### ADDENDUM #3

**PROJECT:** Farmington City  
Ivy Acres Park  
New Park Project

**DATE:** June 14, 2024

**ENGINEER:** Blu Line Designs

Roof Framing Plan

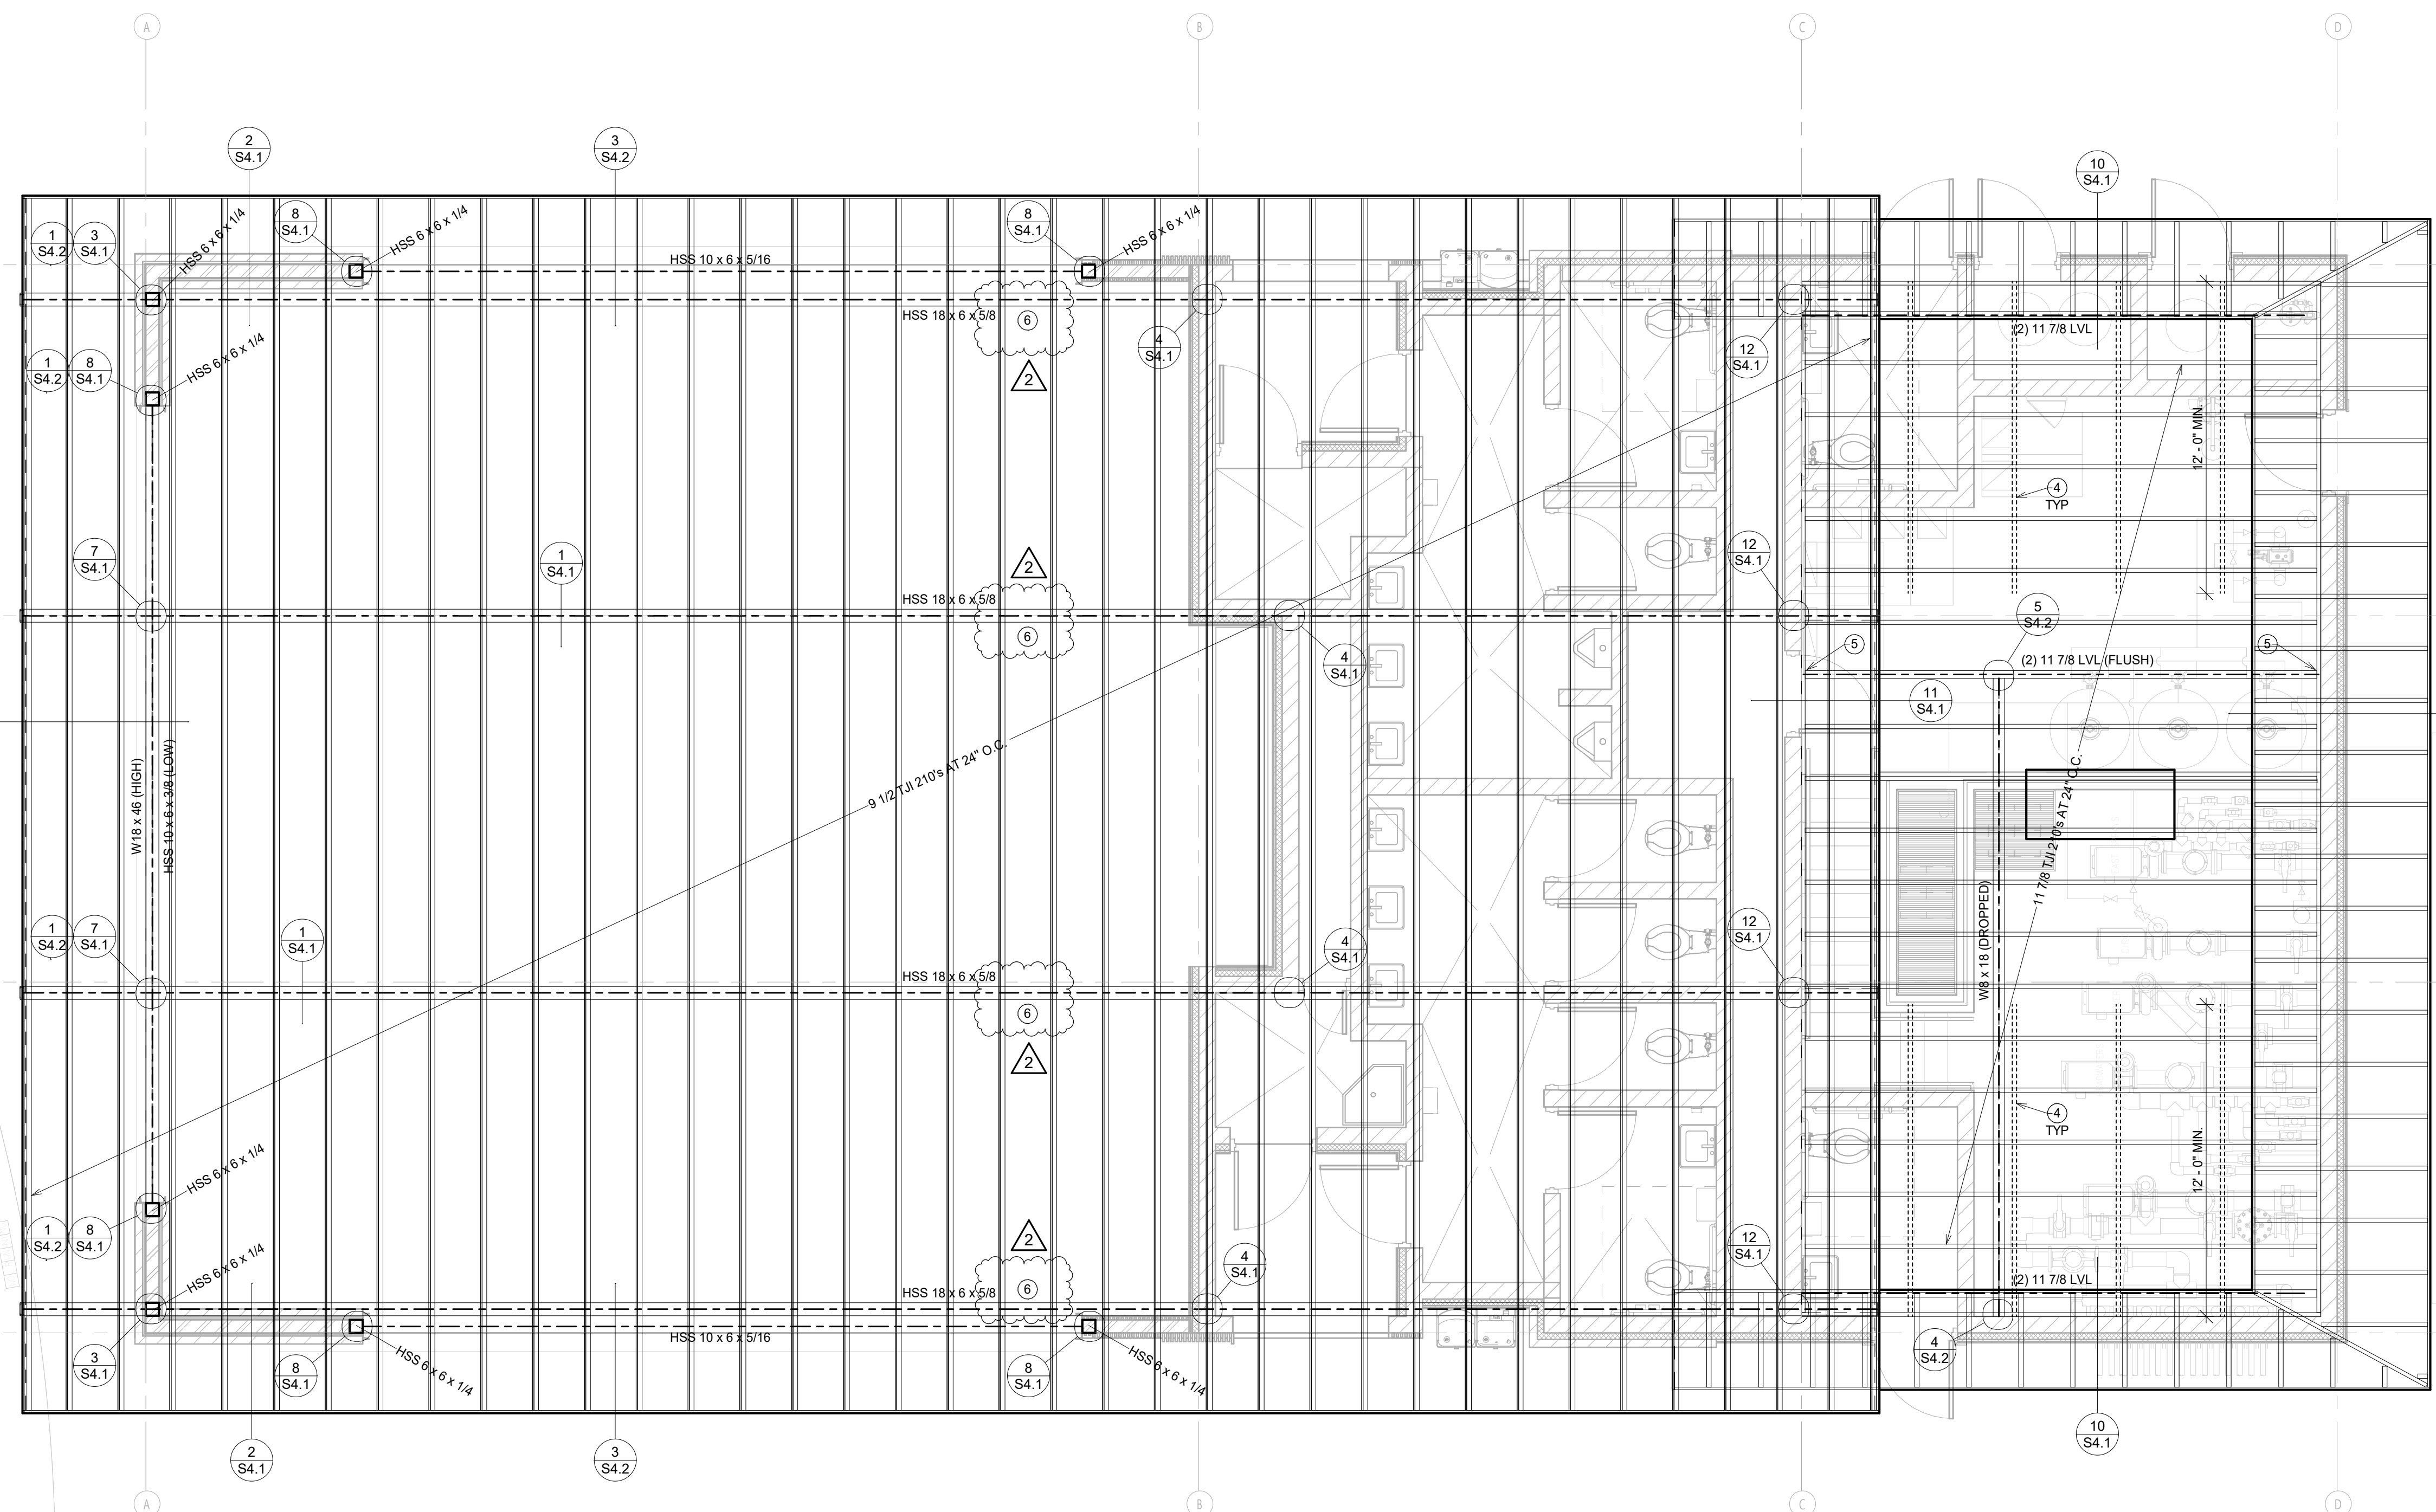
Item 3.4 **A - 7.3:** Approx. 68ft steel beams have an abnormally long span and will require splicing. Please design and advise.

- RESPONSE: S2.1 Added Note 6 to specify beam splice, if necessary.

- 1 FRAME ROOF w/ TJI JOISTS AS CALLED OUT ON LAYOUT
- 2 SEE FRAMING NOTES ON S0.1 FOR ROOF SHEATHING REQUIREMENTS
- 3 SEE S3.1 FOR MASONRY HEADER and WALL CALLOUTS
- 4 SIMPSON CS16 STRAP and BLOCKING AS SHOWN IN DETAIL 10/ S4.1
- 5 SIMPSON HU410. INSTALL WITH 1/4" x 2 3/4" TITEN TURBO SCREWS. FILL ALL SCREW HOLES
- 6 IF SPLICE IS REQUIRED FRO BEAM, PROVIDE FULL PENETRATION GROOVE WELD ON ALL SIDES
